<b>Subject:</b>  <b>AIR TEMPERATURE WILL NOT CHANGE</b>	<b>Bulletin No:</b> 07-003/15
	<b>Last Issued:</b> 11/17/2015

2014-15 Mazda3 (Japan built with manual A/C) with VINS lower than JM1BM\*\*\*\*\*247593 (produced before December 1, 2014)

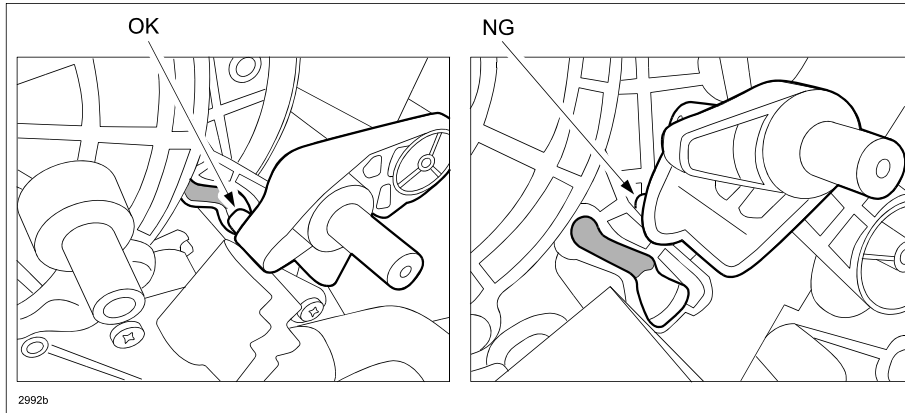
1. Verify customer concern.
2. Refer to the instructions on MS3 online or the Workshop Manual (section 07-40 CLIMATE CONTROL UNIT REMOVAL/INSTALLATION [MANUAL AIR CONDITIONER]) and check that the MIX LINK (Air mix link/Temperature control link) (A) is properly connected to the MIX DOOR CRANK (B) and works while rotating the temperature control knob.

- a. If it works, this Service Bulletin does not apply. Refer to the instructions on MS3 online or Workshop Manual for troubleshooting and repair.
  - b. If the MIX LINK is detached, proceed to the next step.
3. Replace the MIX LINK with a modified one. Refer to MS3 online or the Workshop Manual (section 07-11 A/ C UNIT DISASSEMBLY/ASSEMBLY). Make sure that the MIX LINK is fitted in the groove of the MIX DOOR CRANK and will not come out with movement.
